CITY OF ALBUQUERQUE

**Re: Albuquerque Vault, 300 Airport Drive NW, Grading and Drainage Plan
Engineer's Stamp dated 6-22-05 (K10-D8)**

**CITY OF ALBUQUERQUE
PLANNING DEPARTMENT
DEVELOPMENT SERVICE / HYDROLOGY SECTION**

SUBJECT: Lot B-1 & B-2 Atrisco Business Park

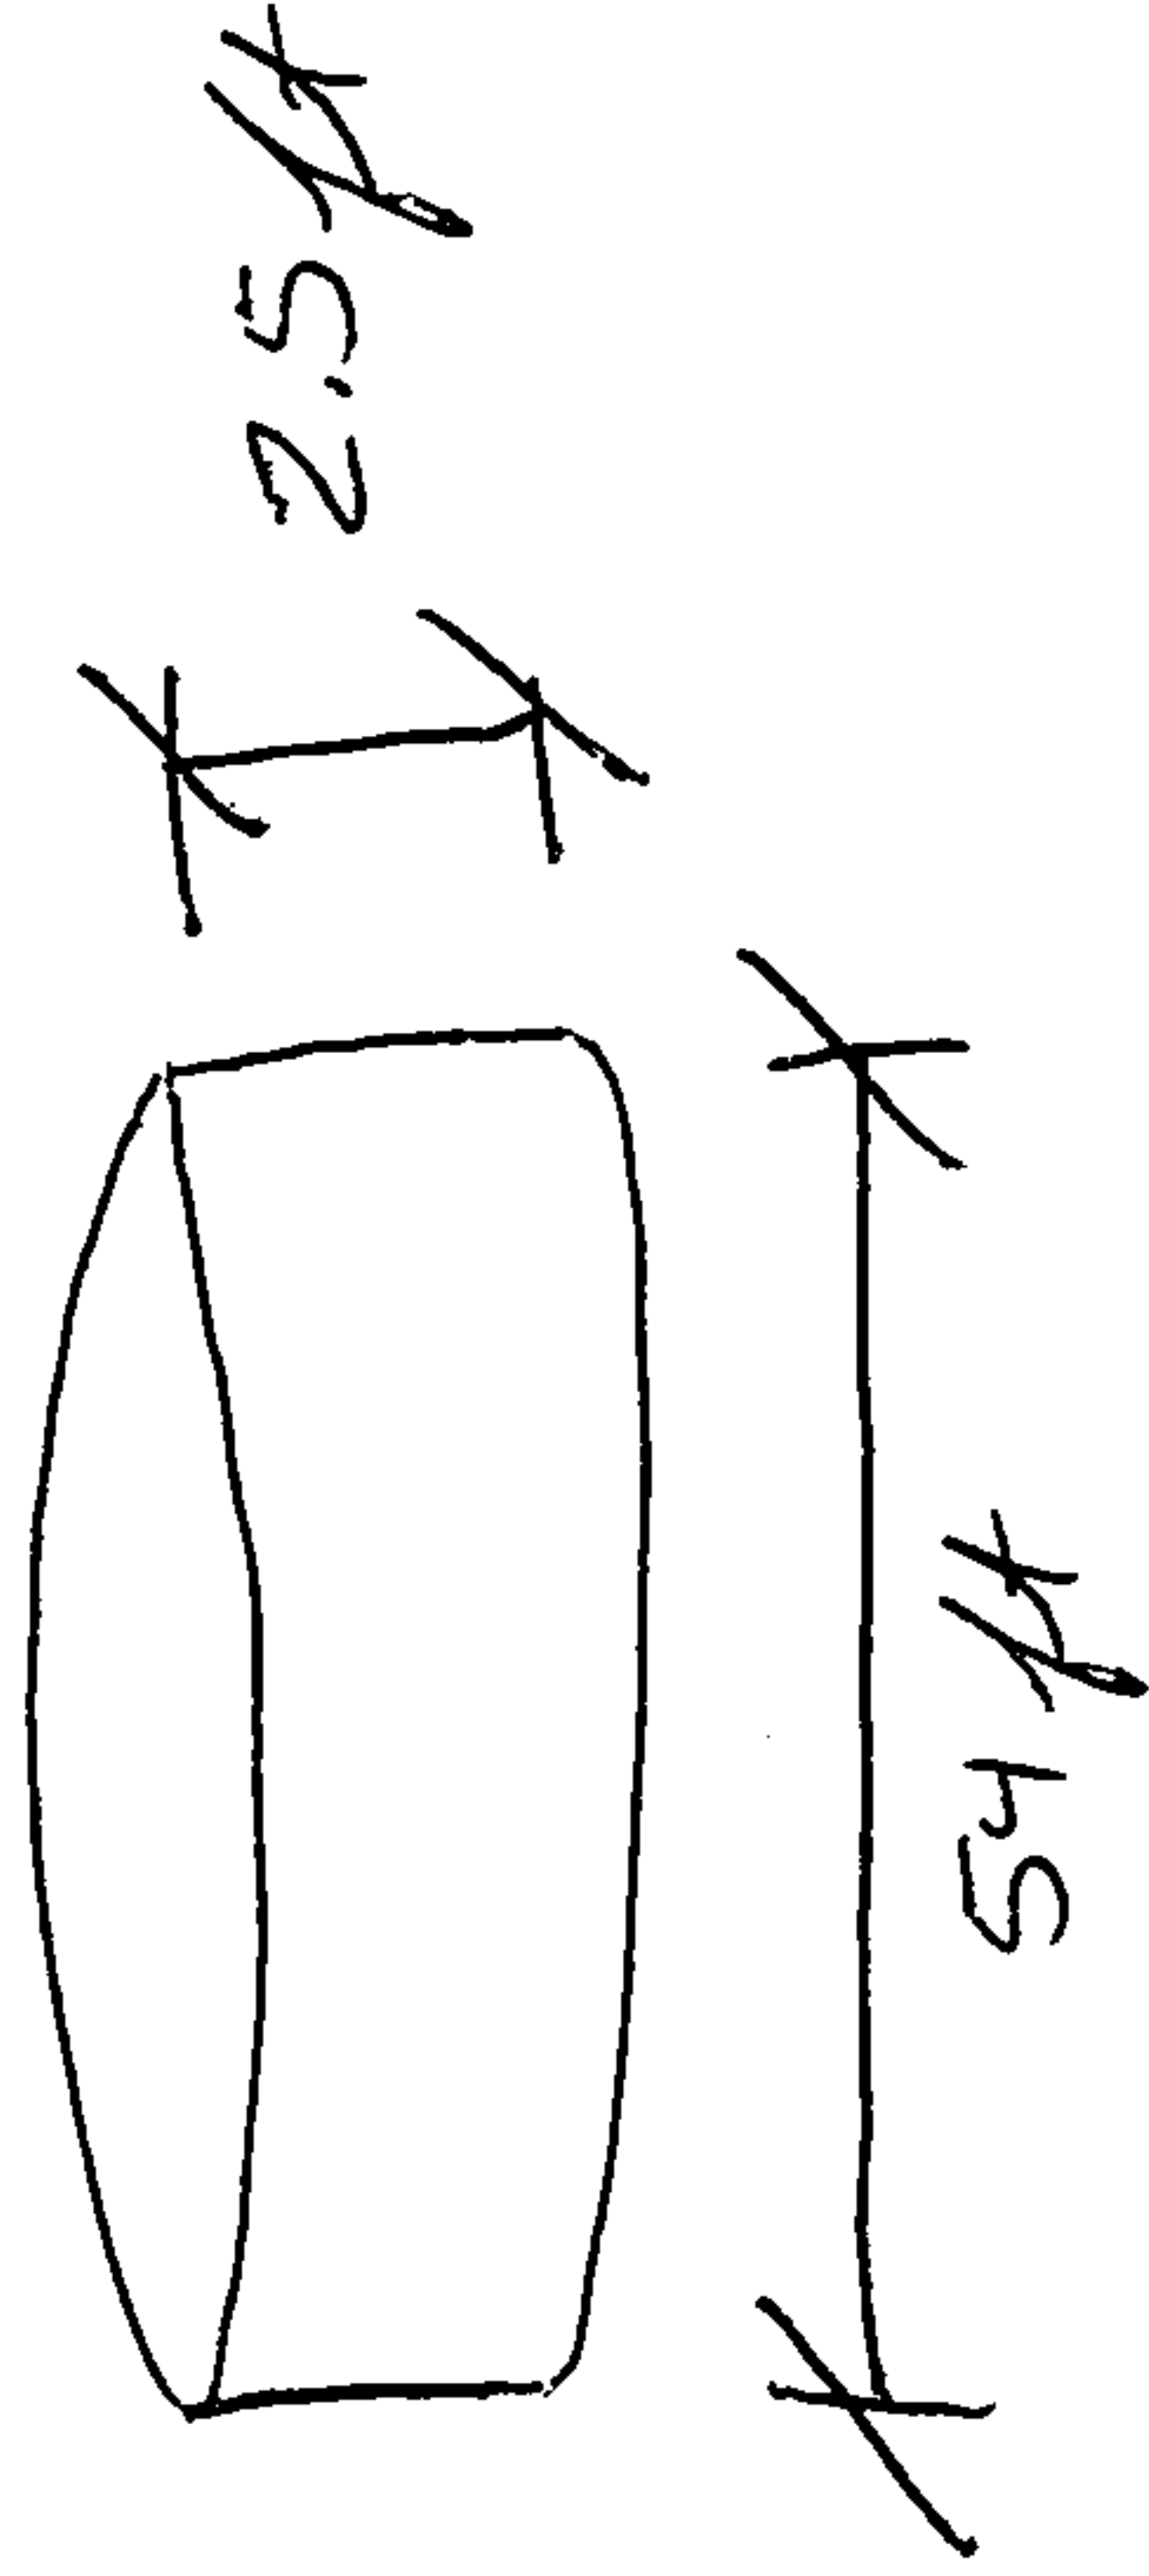
7. The proposed flow calculations are not correct. Note that:

$$\text{Total } Q_P = Q_{PA}A_A + Q_{PB}A_B + Q_{PC}A_C + Q_{PD}A_D$$

Therefore,

$$\text{Existing } Q_P = (1.29)(2.27) + 0 + 0 + 0 = 2.92 \text{ cfs}$$

$$\text{Proposed } Q_P = 0 + (2.03)(0.29) + 0 + (4.37)(1.97) = 9.22 \text{ cfs}$$

Please correct these calculations. In addition, this lot is located within Zone 1, which has different coefficients than Zone 2, which you are currently using. Change these coefficients before the next submittal. Provide existing and proposed E, V, and Q values for this site.
